**Project: Renovate Building 28 First Floor East RRTP**  
**Revision Set: 2 (Prebid Addendum)**

VA Project #: 656-19-306  
Anderson Project # 15451

Date: July 23rd, 2021

1 FIRST SYSTEMS FLOOR PLAN  
1/8" = 1'-0"

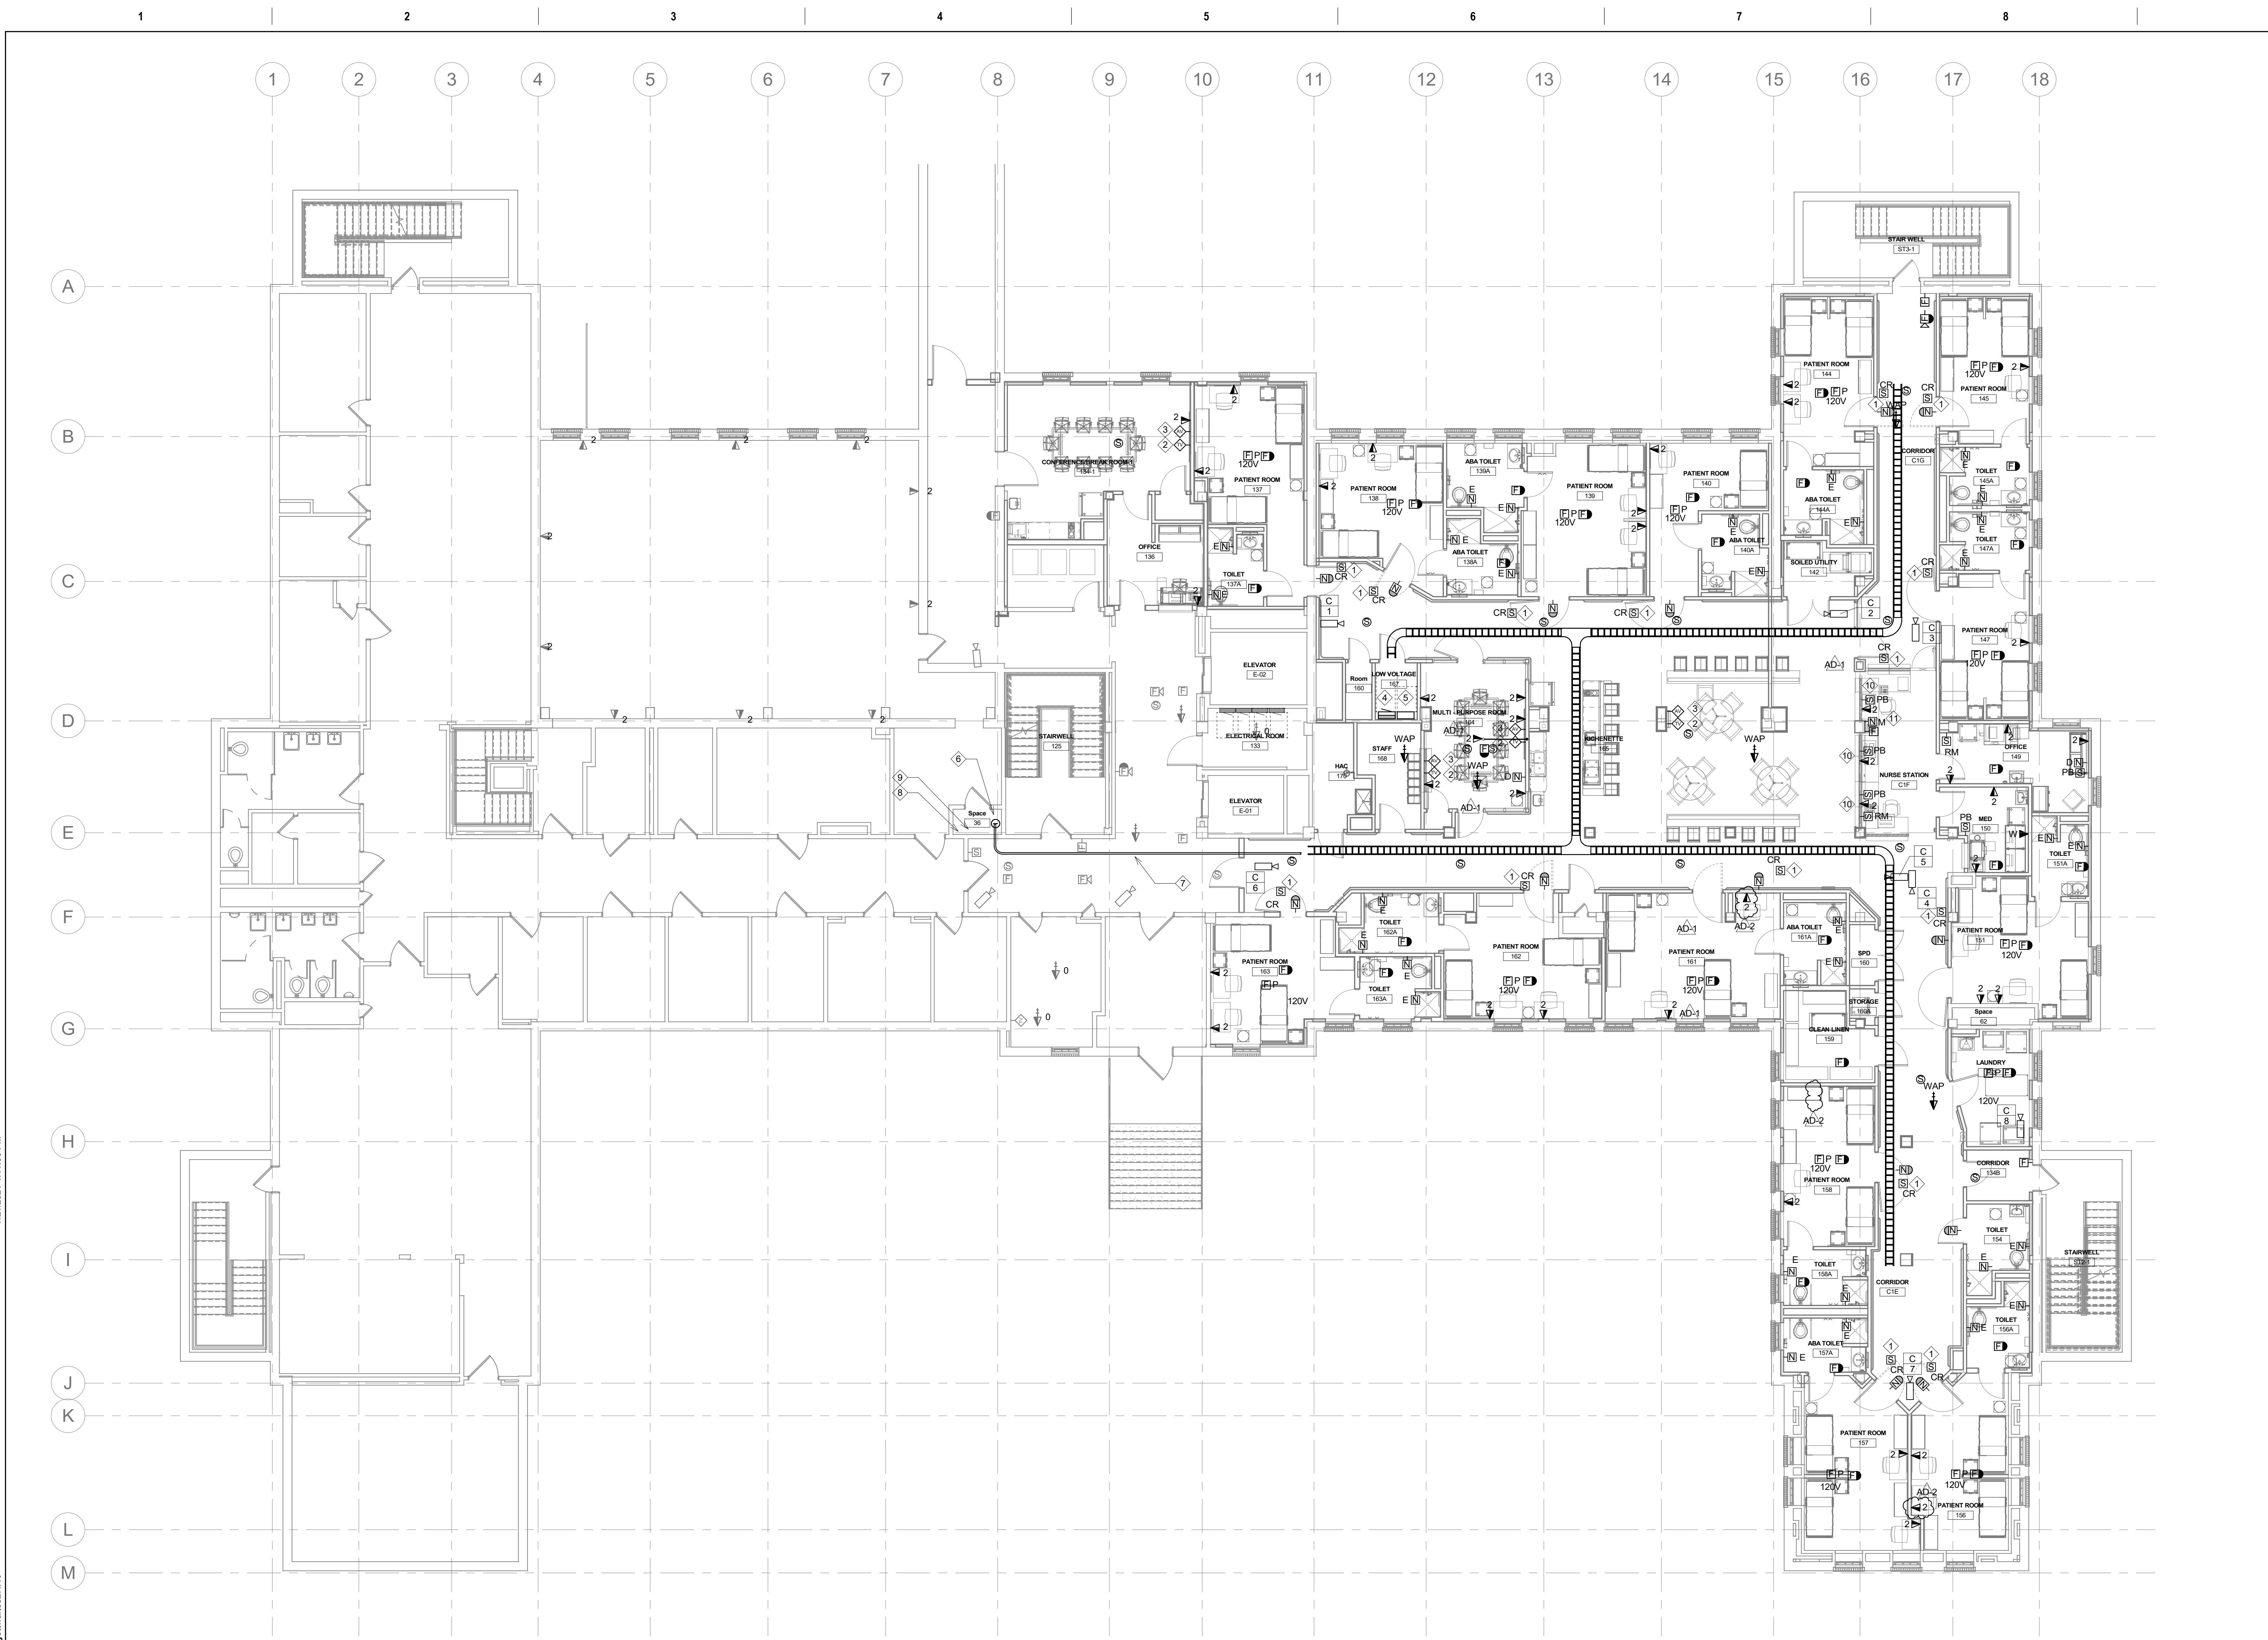
Sheet ES111, First Systems Floor Plan: Revised device layout in patient rooms.
